NSW Independent  
Planning  
Commission

Pitt Street South  
OSD

INTERNAL AMENITY  
SUBMISSION

18 March 2021  
Final

ADG Compliance

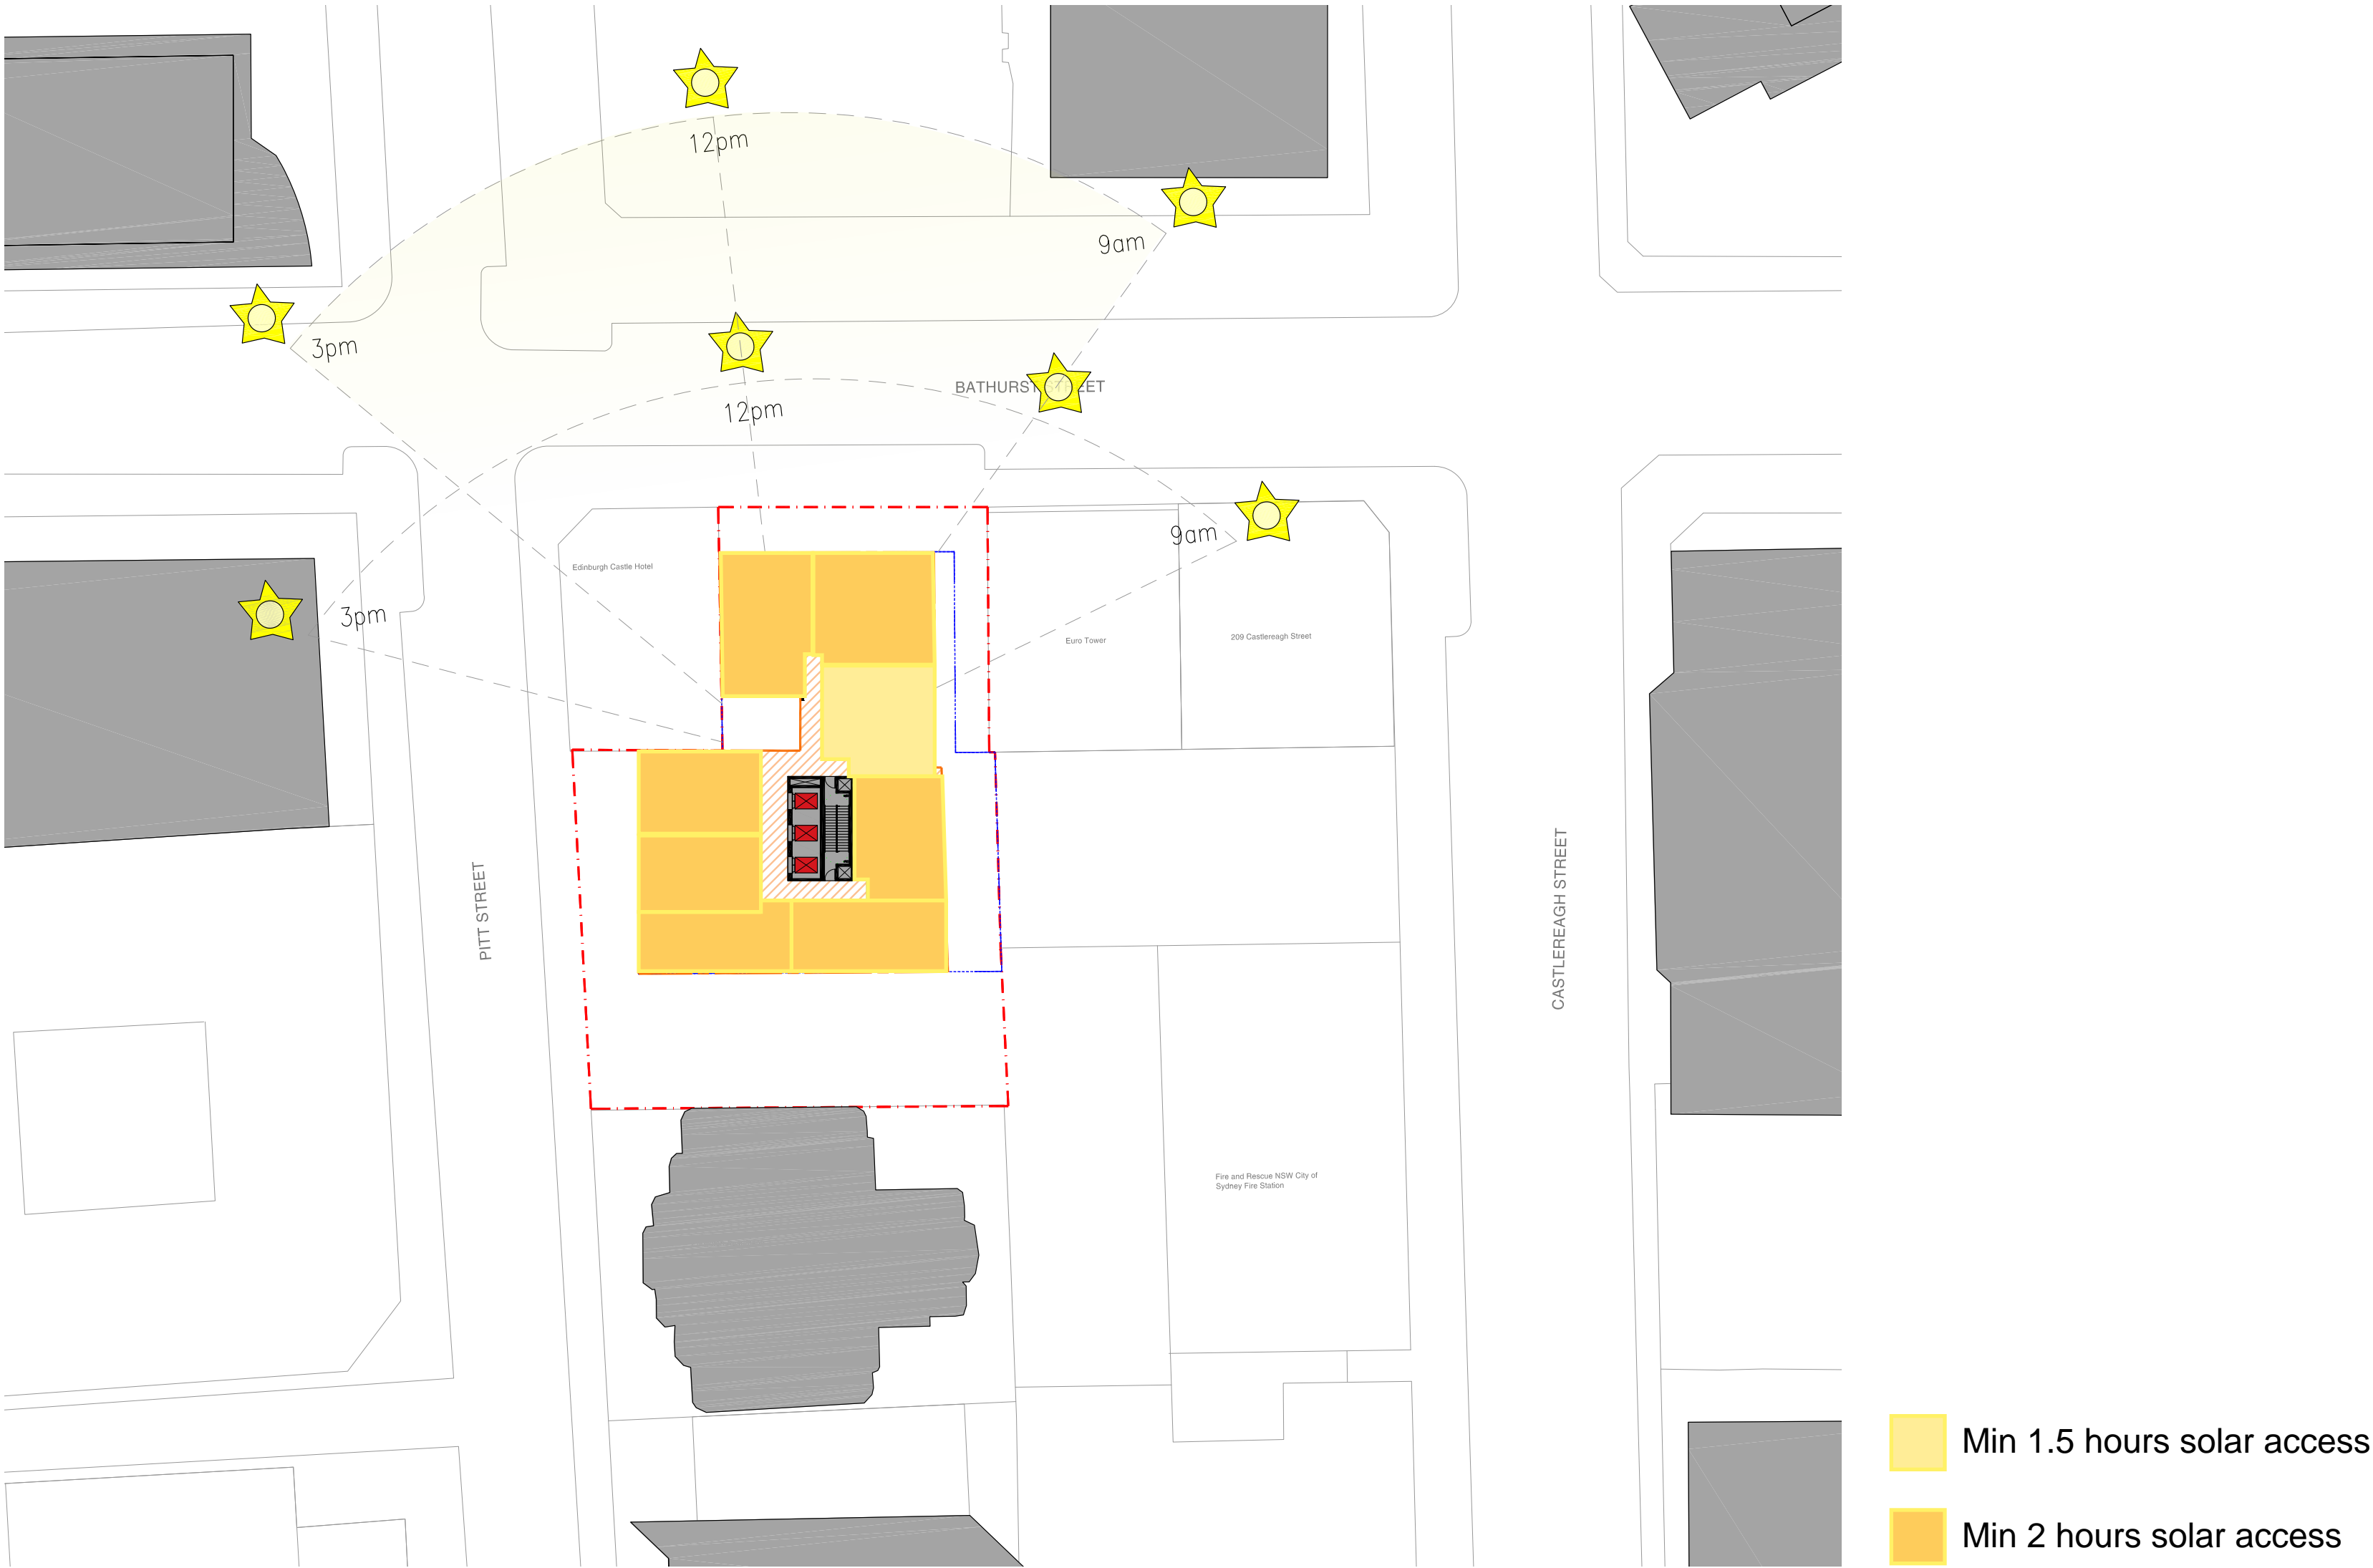
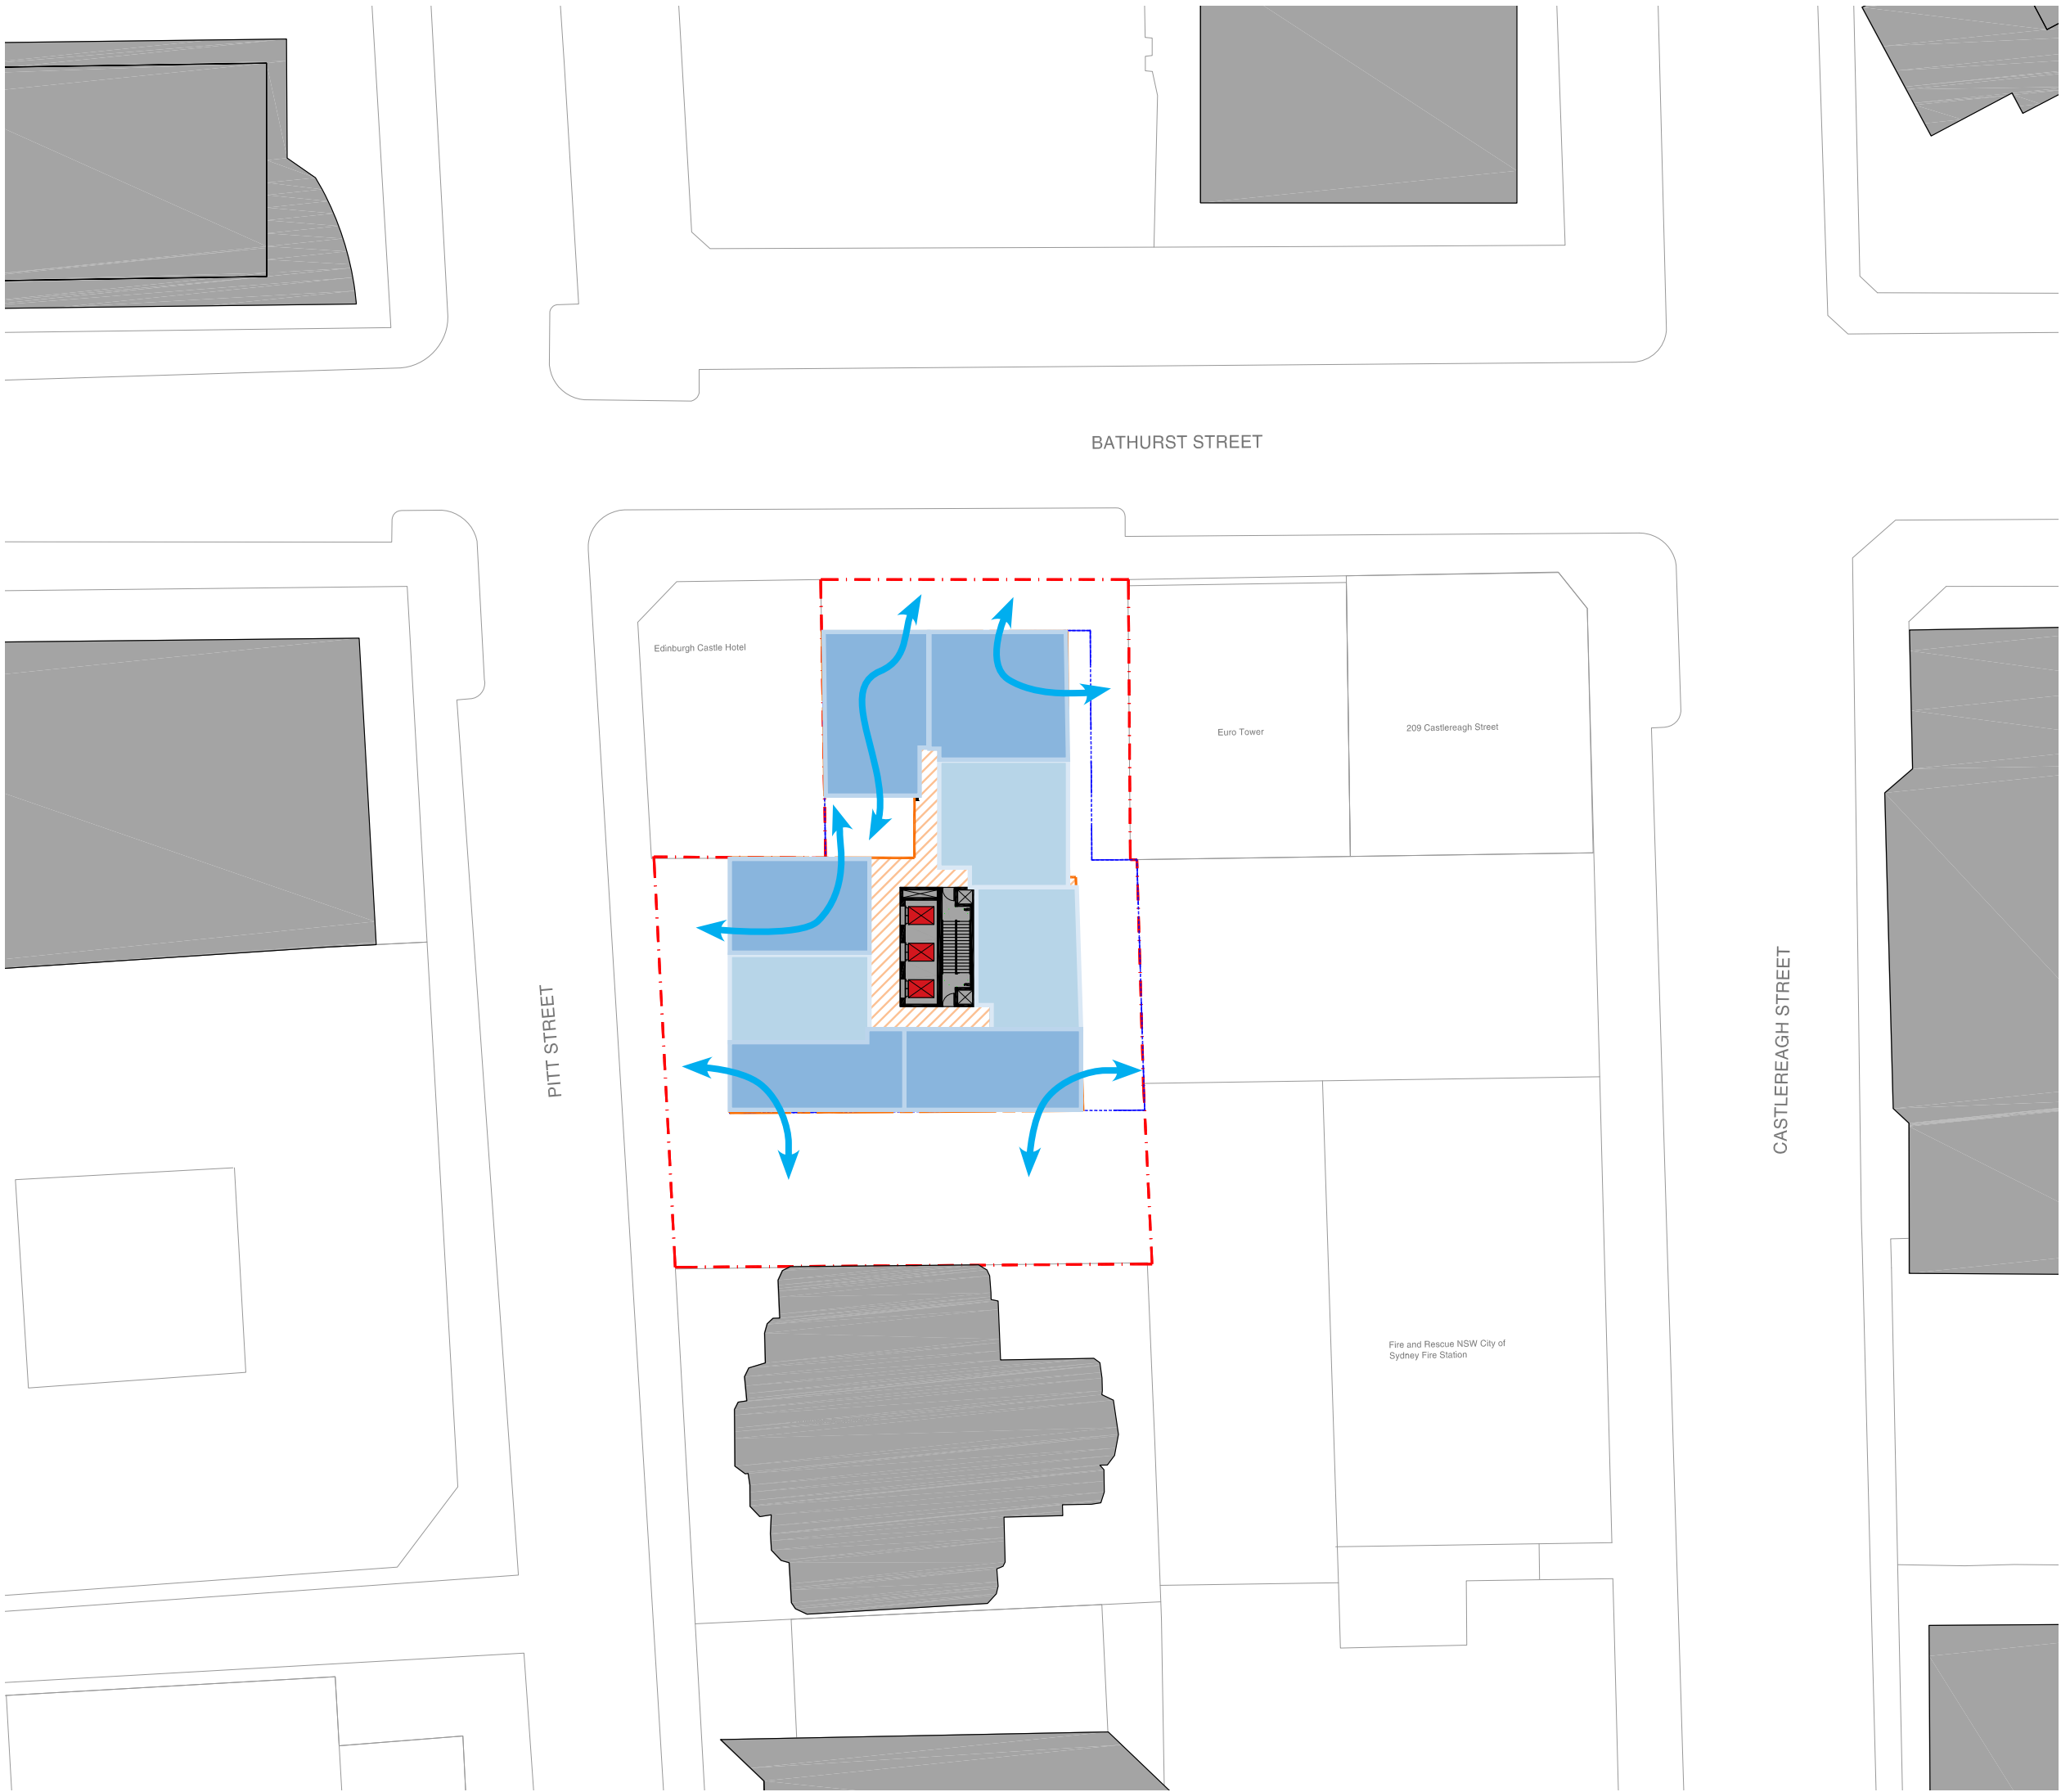
*The Panel raised concerns as to the significant challenges in choosing residential use on this site whilst also pursuing the maximum allowable envelope, noting that the concept design (SSDA) envelope does not distinguish between uses except regarding loading.*

*The design as presented does not satisfactorily achieve sufficient amenity to meet SEPP 65 ADG objectives. The scheme must demonstrate an approach to each boundary condition individually regarding the proposed use, specific conditions, controls and BCA compliance.*

### Response to DEEP Issue #1:

*We have thoroughly analysed the proposed design in relation to the SSDA envelope, BCA controls and and ADG requirements. The propsed design complies with the SSDA envelope setbacks. The design is also fully compliant with BCA light & ventilation requirements as well as BCA light and ventilation, building separation and visual privacy requirements. The proposed design also complies with ADG solar access and natural ventilation requirements, maximum number of apartments per floor and minimum apartment and private open space requirements.*
